PRG Report response to DC Highways report PTE_14_71 dated 22 October 2014

Flow statistics - Pilton Bridge Junction

The chart below (2014) shows the numbers for existing flow using the above traffic count data.

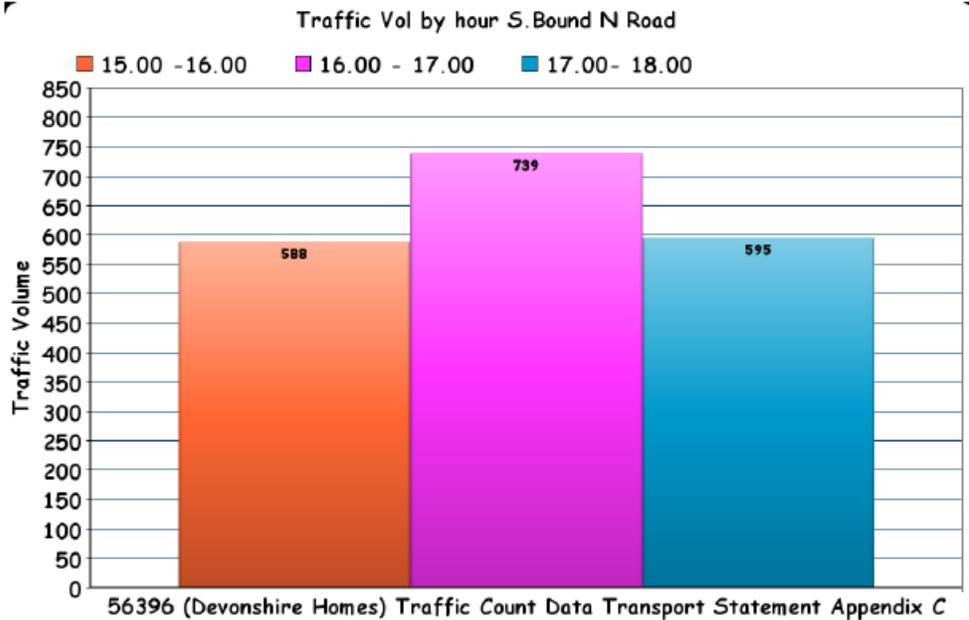
However, depending on how the 15 min interval counts are grouped, the worst case one hour period scenario for 'existing flow' (baseline 2013) could be as high as 739 vehicles.

This is significantly higher than is specified in Fig 2 of the report.

Further more, our chart 2014 shows that the hours either side of peak are also rapidly reaching capacity at this junction.

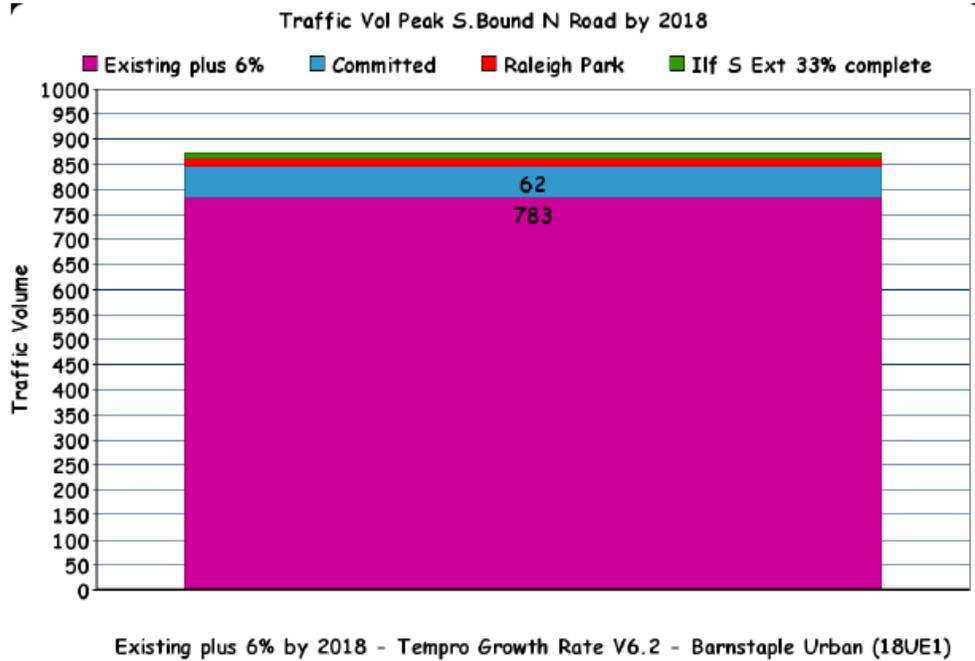
DC highways say in their report that the combined Pilton development will result in an additional 80 vehicles traveling south bound on North Road at p.m. peak.

We are in broad agreement with their calculations using the Trip Rate Model shown in the same Devonshire Homes assessment and factoring in all proposed developments.

The final chart (2031) shows the predicted flow by 2031 and takes into account a further extrapolated 10% growth over the next 13 years. This only factors in the currently approved 750 dwellings for the Ilfracombe Southern extension.

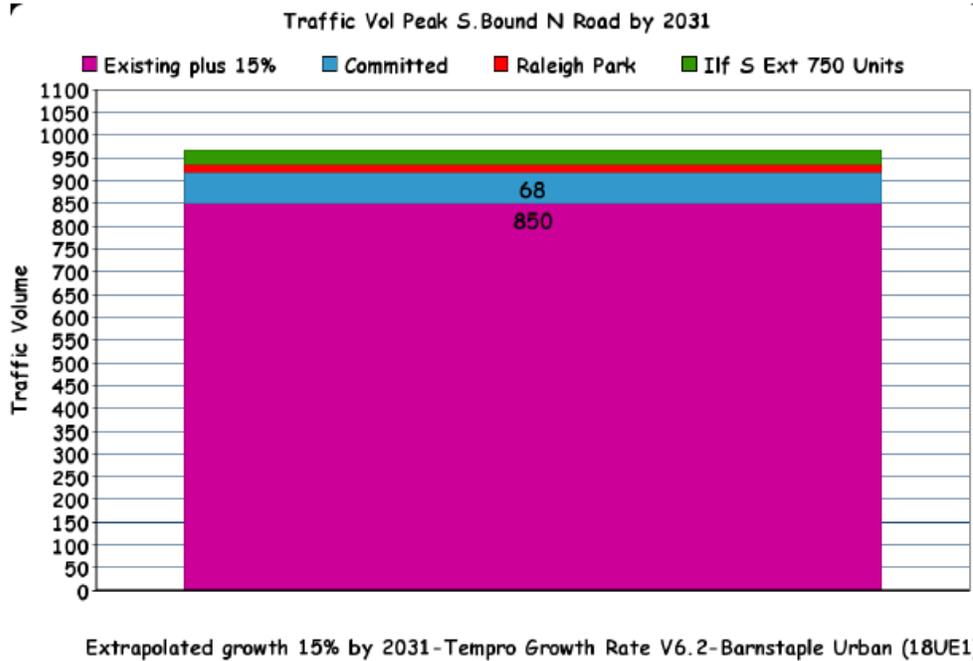
This component doubles if all of the proposed 1400 dwellings in the N.D. and T. Draft Local Plan are approved taking the total to approximately 1000 vehicles during this one hour period.

We must conclude that the figures produced in report PTE_14/71 do not portray an accurate picture of current traffic flow for this 'at capacity' junction and certainly do not take into account the impact of the Ilfracombe Southern Extension and accepted growth factors.
